ADDENDUM

Project: PSC Fire Alarm Upgrade

Project No.: 23-131

Addendum No.: 1

**SECOND FLOOR FIRE ALARM NEW**
SCALE: 1/8" = 1'-0"

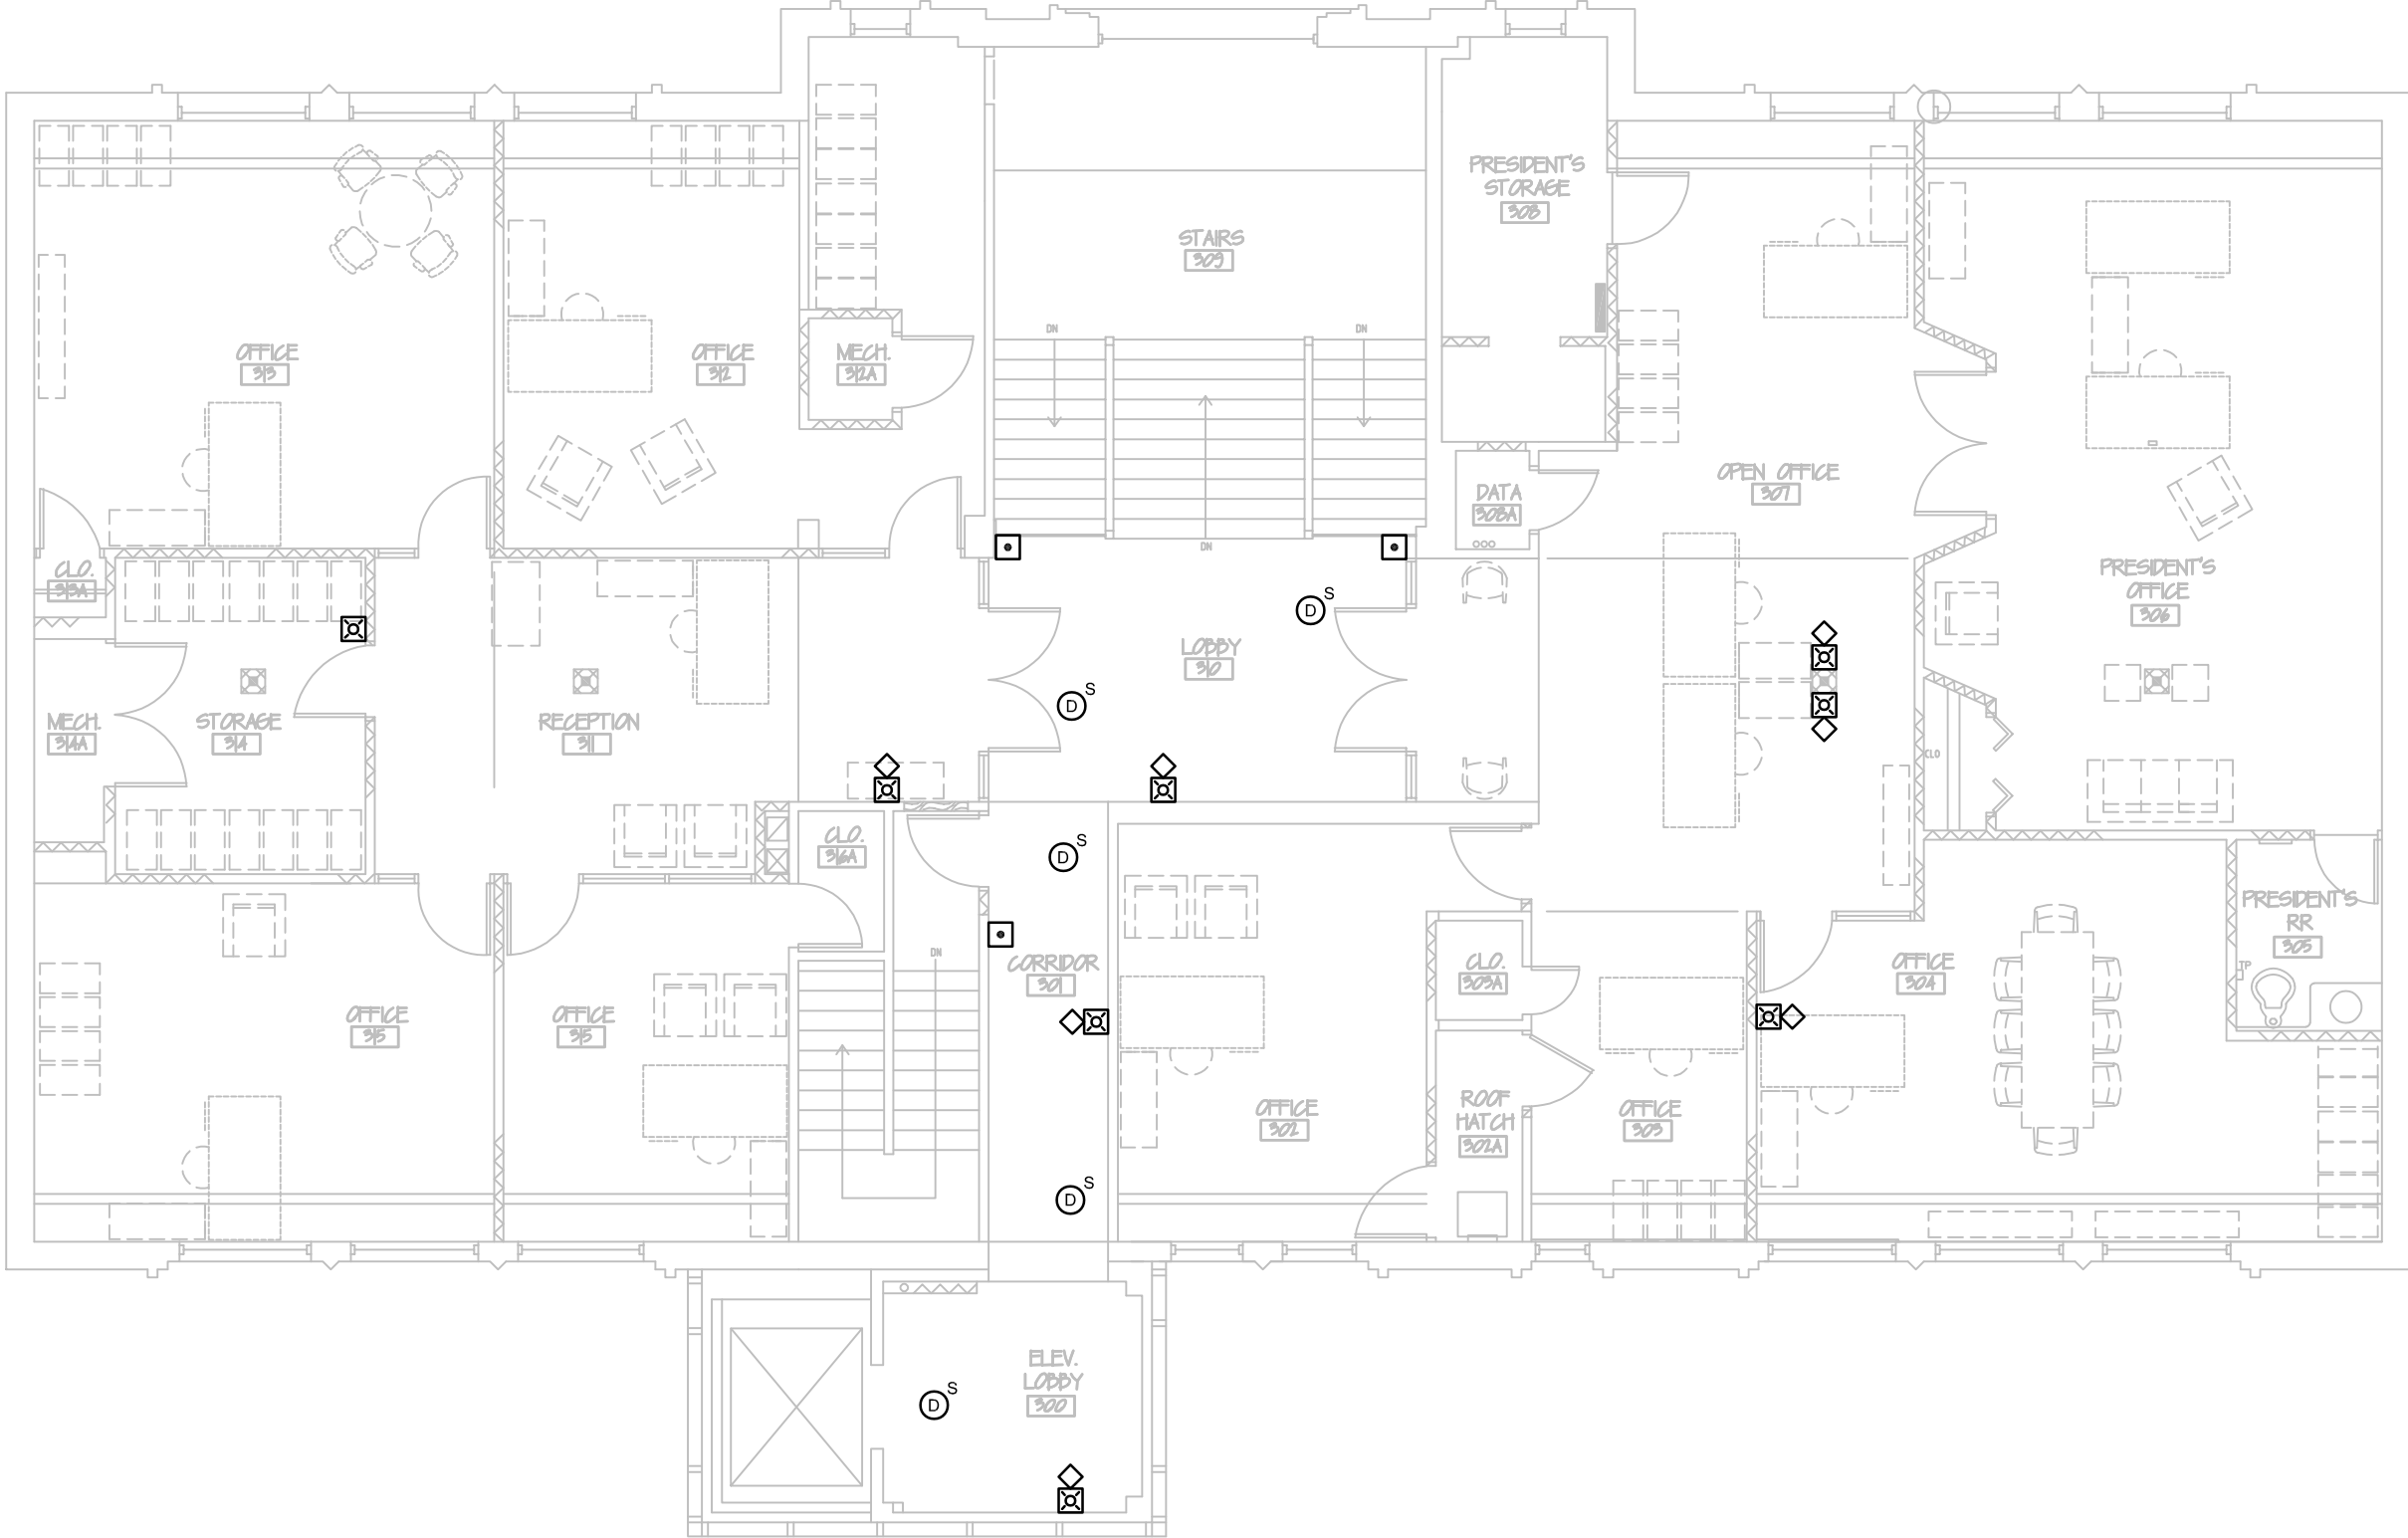
1. Added flow and tamper switch locations.
2. Added duct detectors.
3. Added PIV location.
4. Added WP horn/strobe.

JINDRA - BASEMENT
FIRE ALARM - NEW

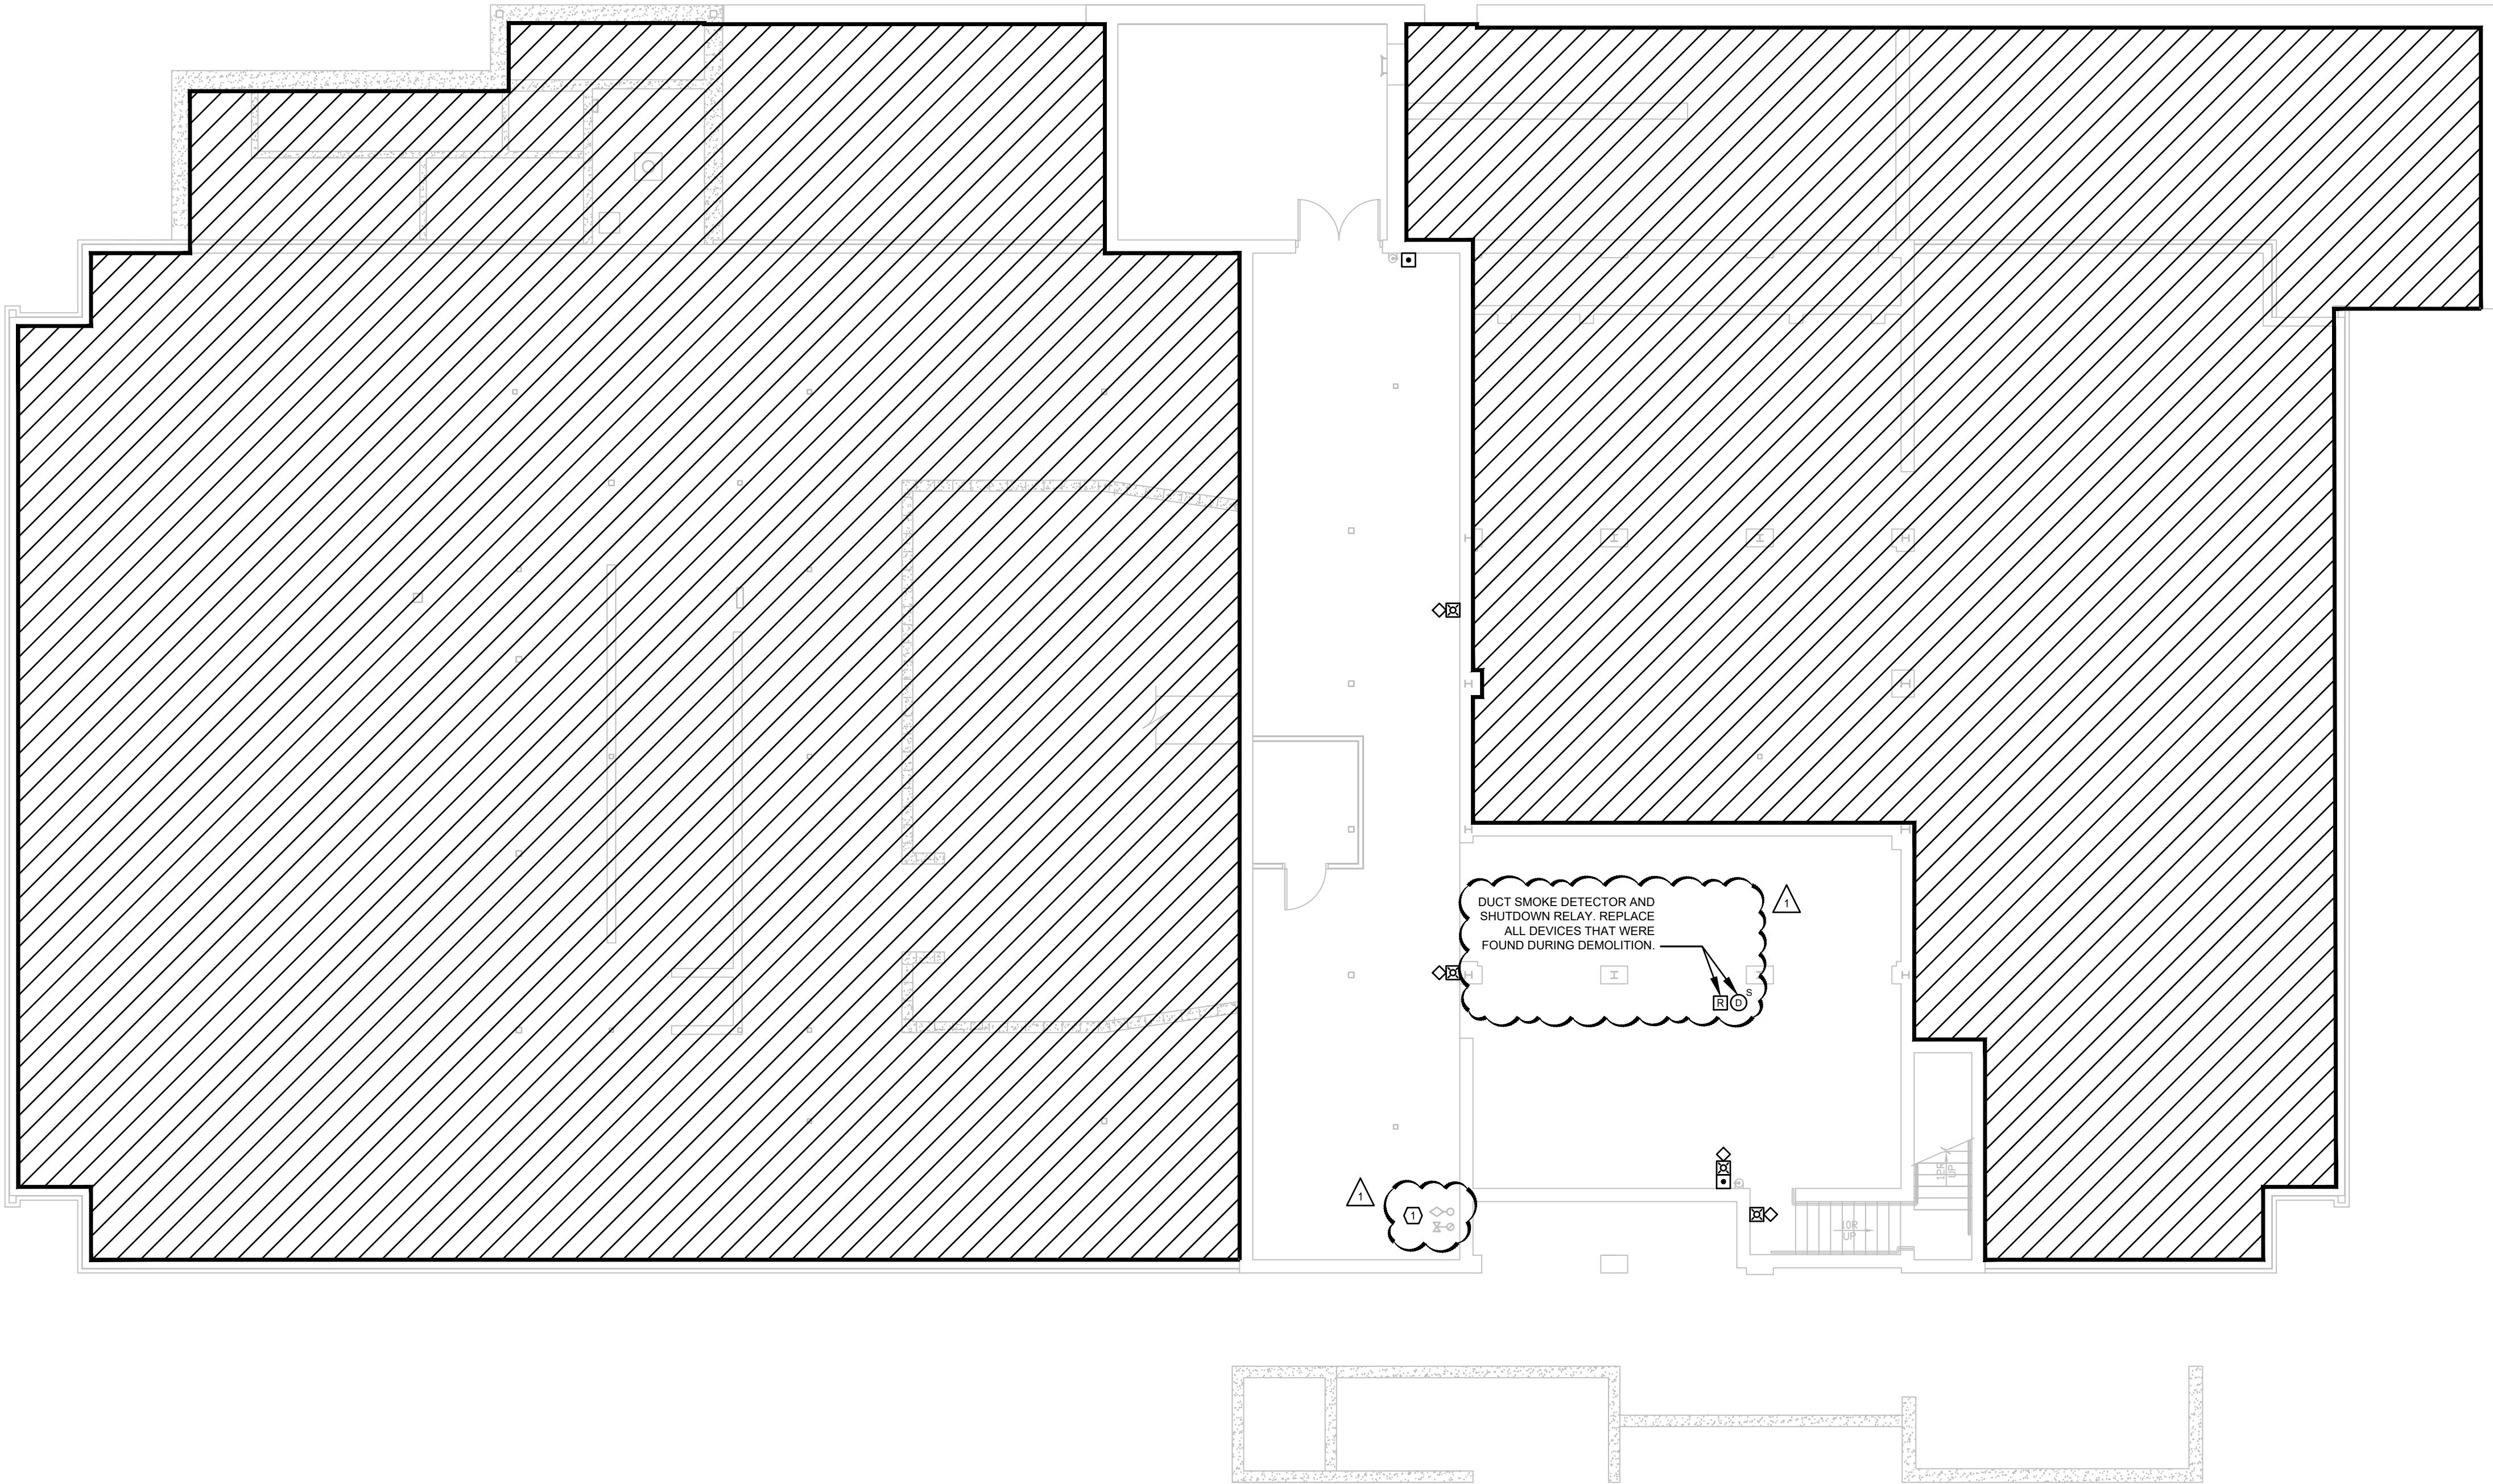
1. Added flow and tamper switch locations.
2. Added duct detectors.

JINDRA - 1ST FLOOR
FIRE ALARM - NEW

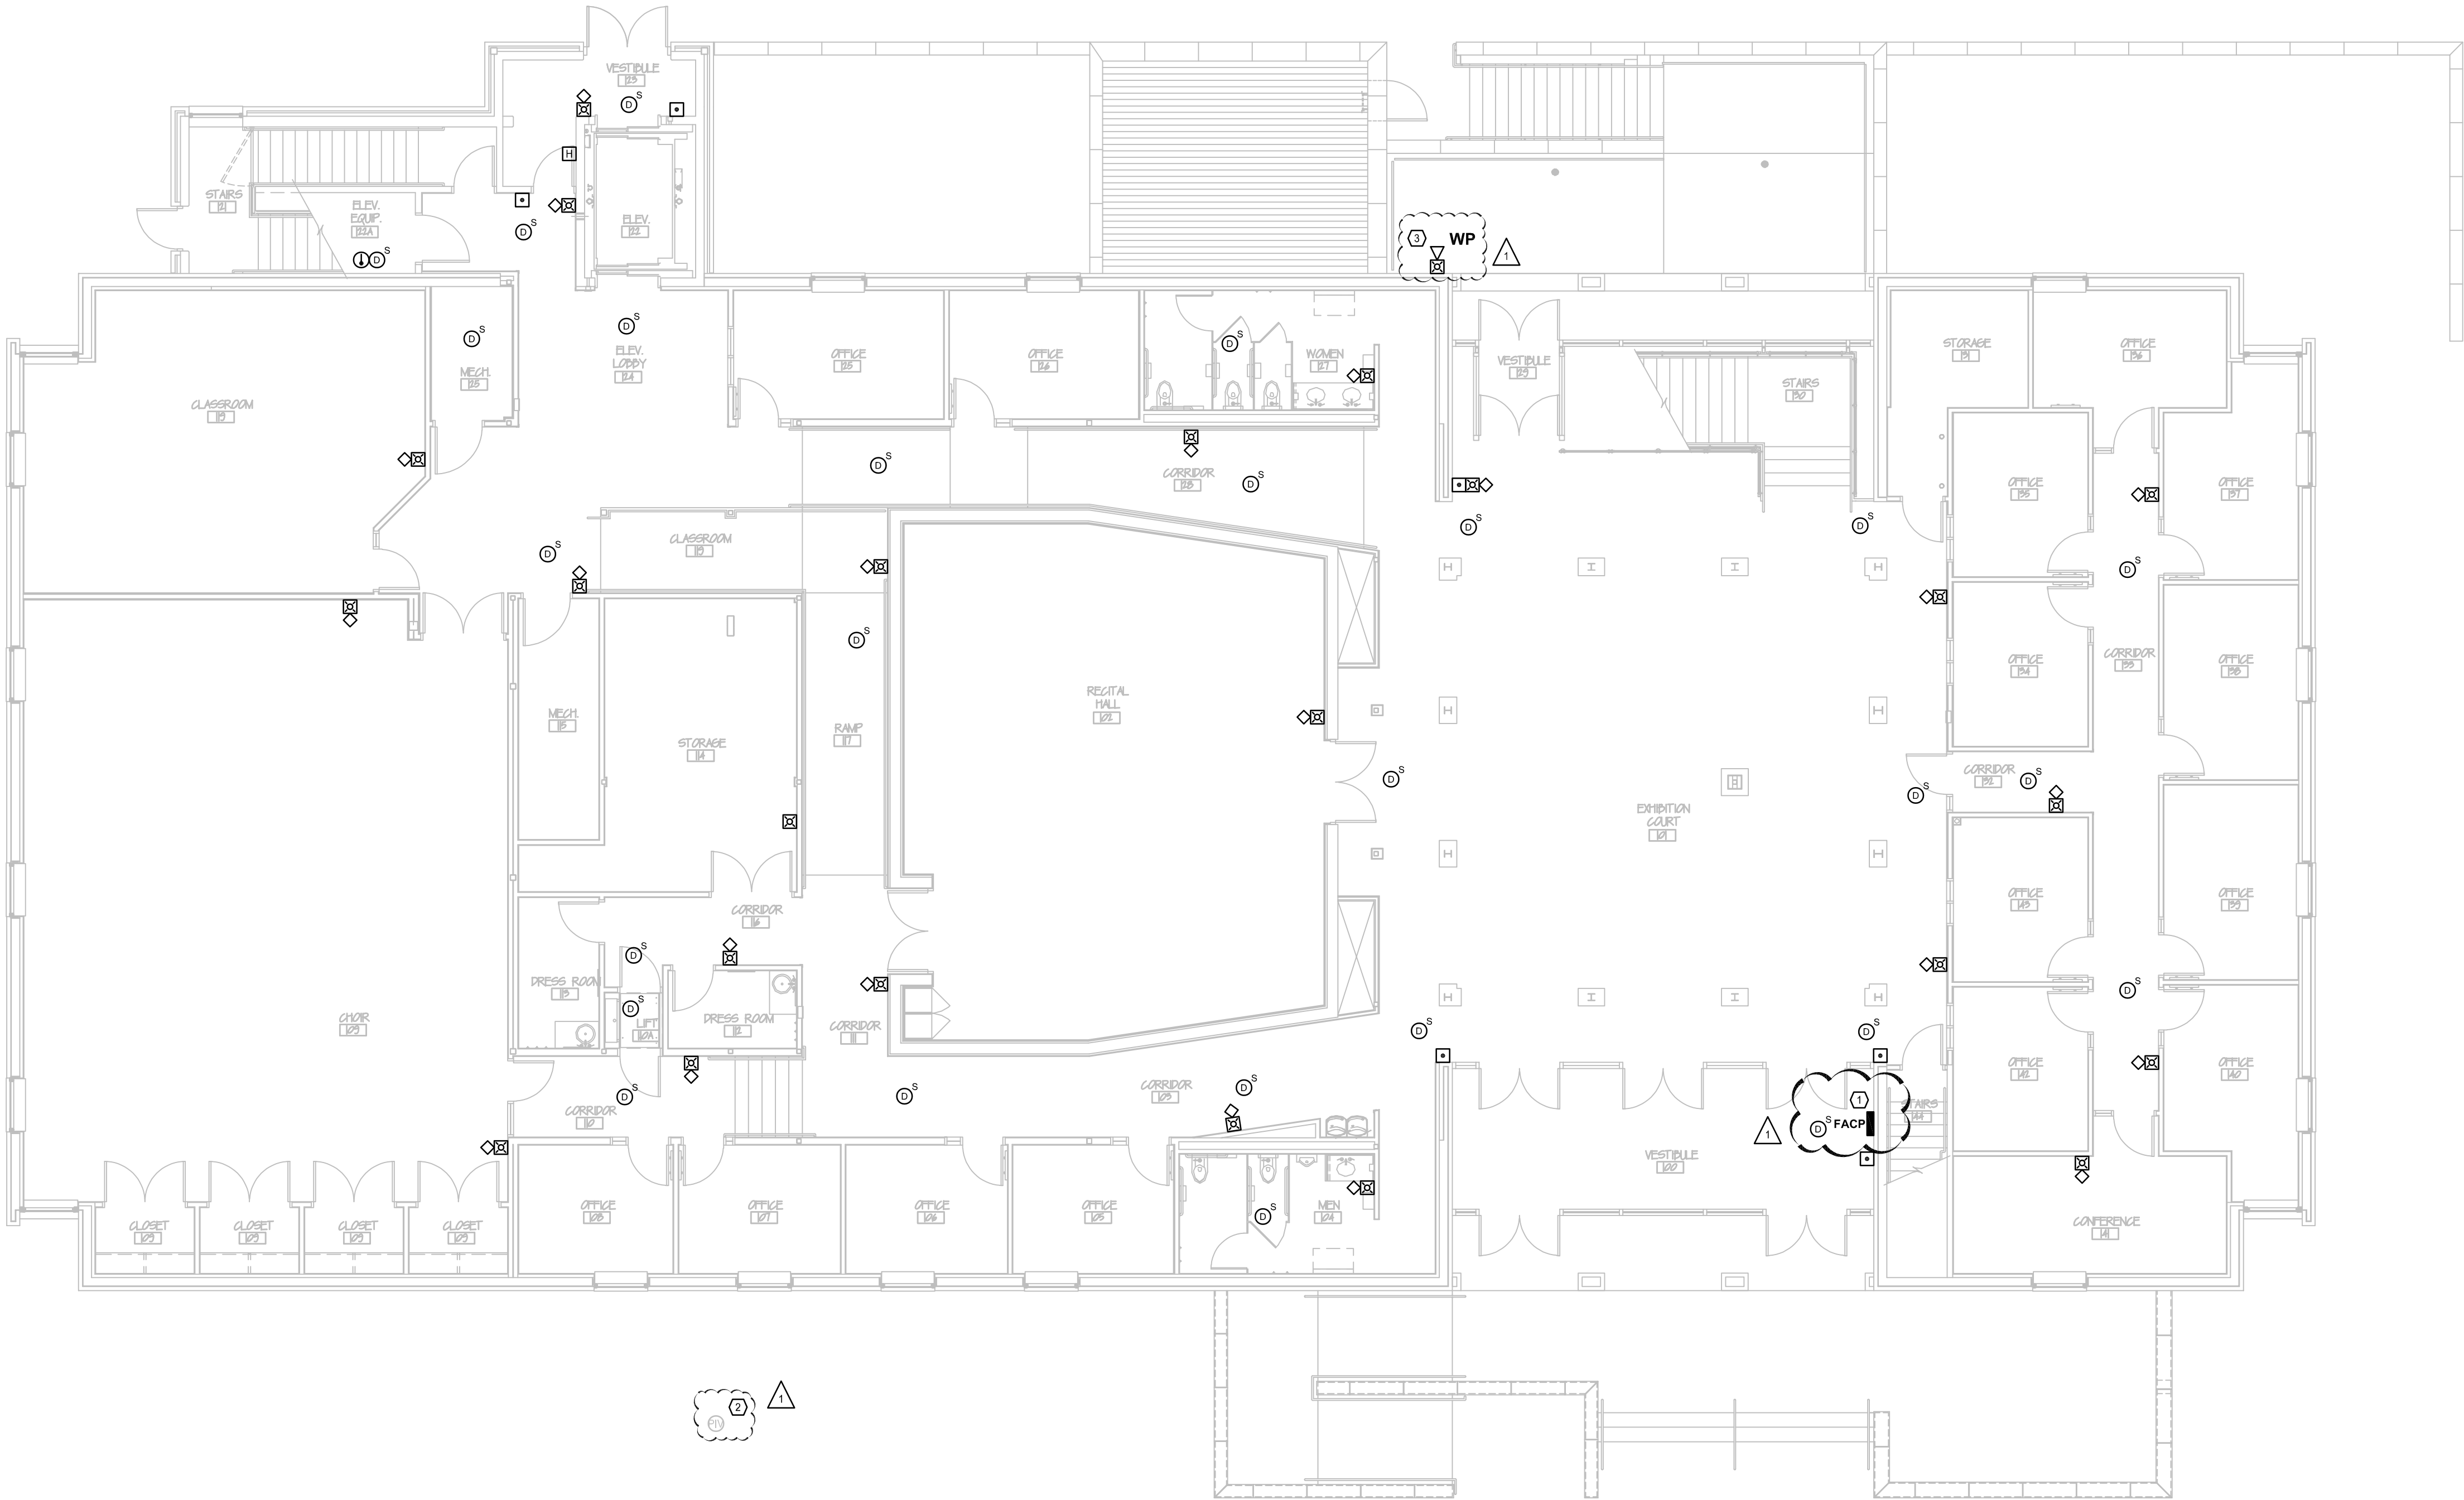
1. Added PIV location.
2. Added smoke detector.
3. Added WP horn/strobe.
